M42 Junction 6 Development Consent Order

8.11 Statement of Common Ground with Warwickshire Wildlife Trust

STATEMENT OF COMMON GROUND
WARICKSHIRE WILDLIFE TRUST

This Statement of Common Ground has been prepared and agreed by (1) Highways England Company Limited and (2) Warwickshire Wildlife Trust.

Figure 1: M42 Junction 6 Improvements – General Arrangement
 (source: extract from drawing HE551485-ACM-HGN-M42_GEN_ZZ_ZZ-DR-CH-0012 P02.3)

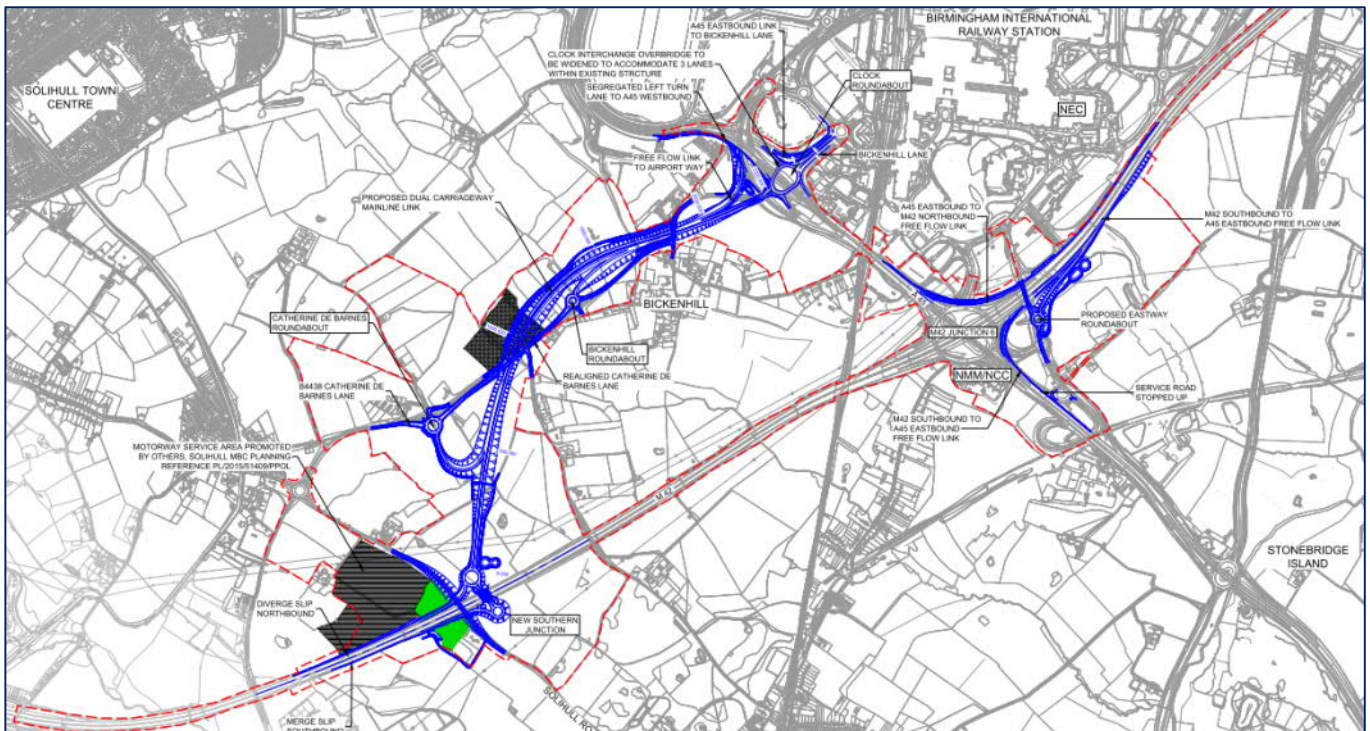
Sub-topic	Warwickshire Wildlife Trust Comment	Highways England Response/Actions	Status/Agreement-
Biodiversity			
	The Trust are concerned that the evidence informing the DCO application is insufficient to understand the hydrology of the site and therefore the required mitigation to protect the grassland habitat	Highways England are continually collecting and evaluating data to better understand the interaction the Scheme may have on the Shadowbrook Meadows SSSI unit. The spatial extent and duration of monitoring has been agreed with Natural England and the Trust has not objected with these parameters in meetings held to date.	Agreed
Bickenhill Meadows SSSI	Would Highways England be happy with a pumping option as mitigation for the SSSI?	<p>The solution presented within the DCO Application for the Scheme was informed by the data collected at the time of submission. As such and if required, this solution can be implemented and operated to mitigate the impact to the Shadowbrook Meadows Unit of Bickenhill Meadows SSSI.</p> <p>Highway England are collecting data and seeking to refine the mechanical components of any solution to a minimum to reduce the risk of failure or fault, with the aim of implementing a mitigation solution with little or no mechanical components.</p>	Under Discussion
